CITY OF CARPINTERIA
ARCHITECTURAL REVIEW BOARD
Meeting of April 16, 2015

COMMUNITY DEVELOPMENT DEPARTMENT PROJECT REVIEW

Project: 14-1747-CDP **Planner:** Nick Bobroff
Address: 4640 Ninth Street
APN: 003-242-017
Zoning: Single Family Residential (4-R-1)
Applicant: Gordon Statler for Terry and Lynda Krausgrill

Project Review:
☐ Conceptual
☐ Preliminary
☑ Final

SITE PLAN

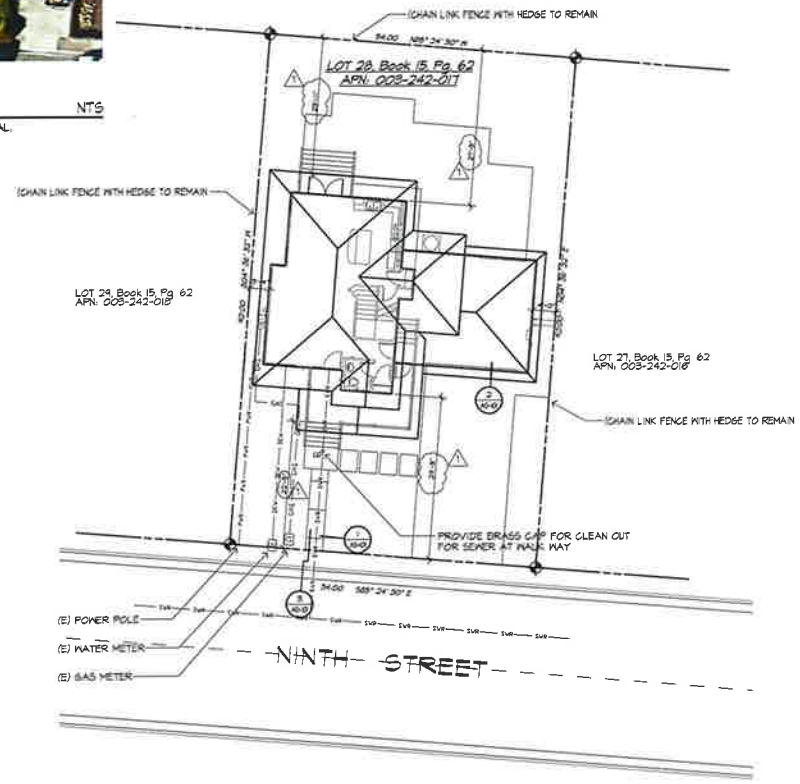
During the discussion of the project, it was noted that moving the house back to meet the front setback would help to mitigate the residence's height as viewed from the street. The applicant also provided an exhibit demonstrating that the proposed hip roof reduced the residence's perceived height as viewed by a pedestrian compared to the same house with a slightly lower, gable roof. The Board considered ways to reduce or eliminate some of the cantilevered elements of the second floor, but acknowledged there were limited opportunities for adjustments given the lot coverage and floor area ratio constraints.

Several updates and revisions have been made to the plans in response to comments/direction received from the ARB and CDD staff: The site plan has been revised so the new residence conforms to the applicable front setback requirements. The revised front setback is 22 feet six inches, an increase of eight feet from the original plan. The (original) landscape plan will need to be updated to reflect the new site plan layout.

EXTERIOR ELEVATIONS 1/4"

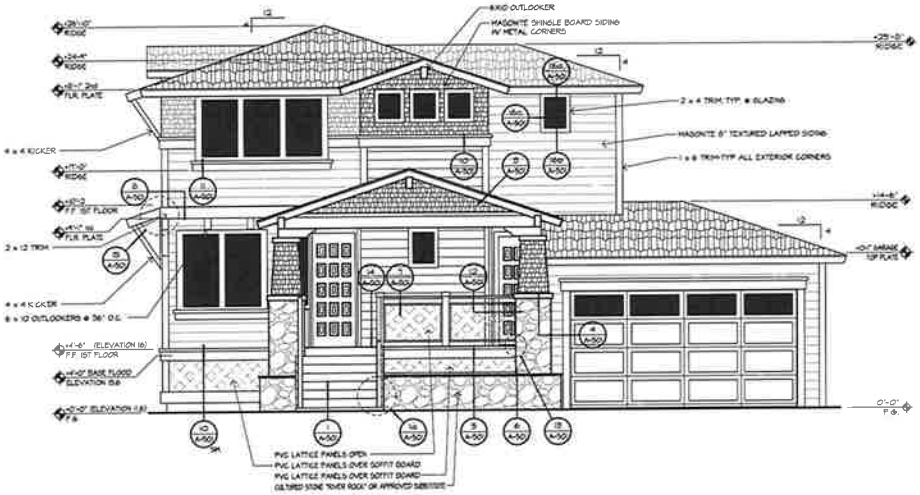
- Restudy the front porch. Eliminate the intermediate supports and make the end columns a more substantial element;
- Select a more decorative garage door; possibly a double door if feasible;
- Add fenestration to the east (side) elevation of the garage; and
- Make corner trim more substantial.

Boardmember Johnson suggested that a more decorative garage door be selected, possibly a double door if possible. He also suggested a couple of small windows could be added to the east elevation of the garage. He noted he generally liked the sizing and placement of windows on all elevations. He did, however, feel the porch needed to be restudied (as suggested by Boardmember Ellinwood) and he thought the corner trim could be made more substantial.

In response to the ARB's comments, the front porch has been revised to eliminate the intermediate supports. The remaining columns at each end of the porch have been made more substantial (12"x12" stone veneer base with tapered shingled columns). Decorative trim, including corner trim, has been made more substantial throughout. A more decorative garage door is shown, and a pair of windows has been added to the east (side) elevation of the garage.

BUILDING SECTION "A" :1/4"

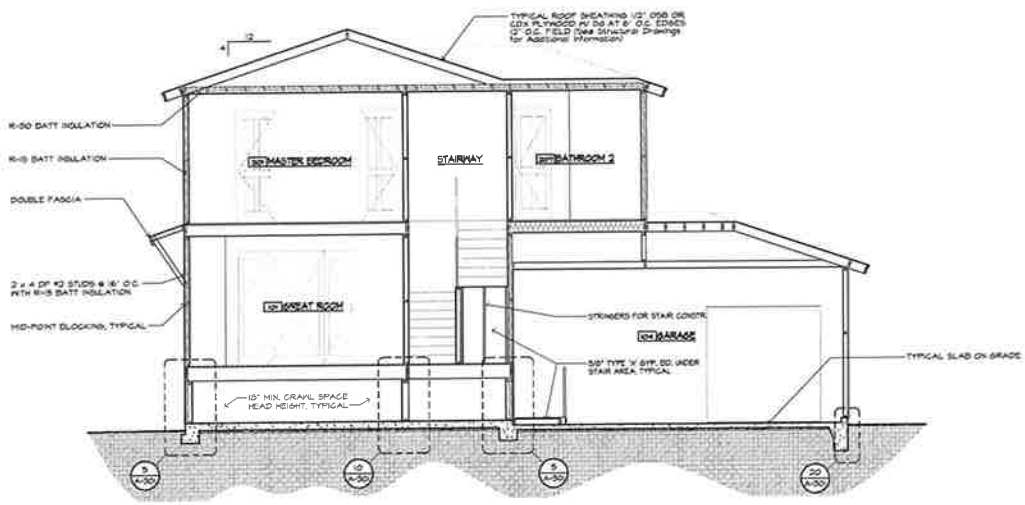
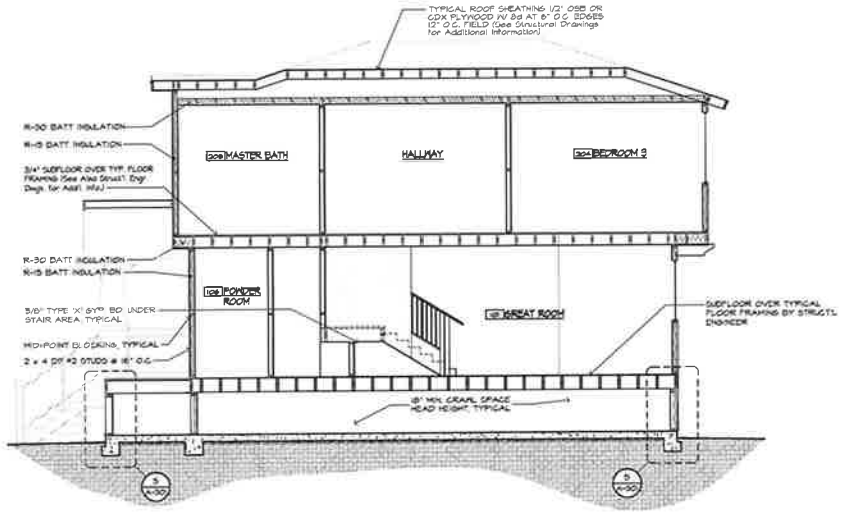
Updated plans reflecting the ARB's comments were submitted to Community Development on February 20, 2015. The Community Development Director reviewed and approved the updated project on March 18, 2015. As a condition of approval, the Director required the maximum height of the residence to be reduced by one foot (from 27 feet 10 inches to 26 feet 10 inches).

In response to the condition requiring a one-foot reduction in total building height, the second floor plate height has been reduced from nine feet down to eight feet. To make up for the loss of second floor ceiling height, the applicant intends to vault the second floor hip roof. A gabeled dormer feature has also been added to the southwest corner of the (west) side elevation to provide additional head room and natural light at this corner of the master bedroom.
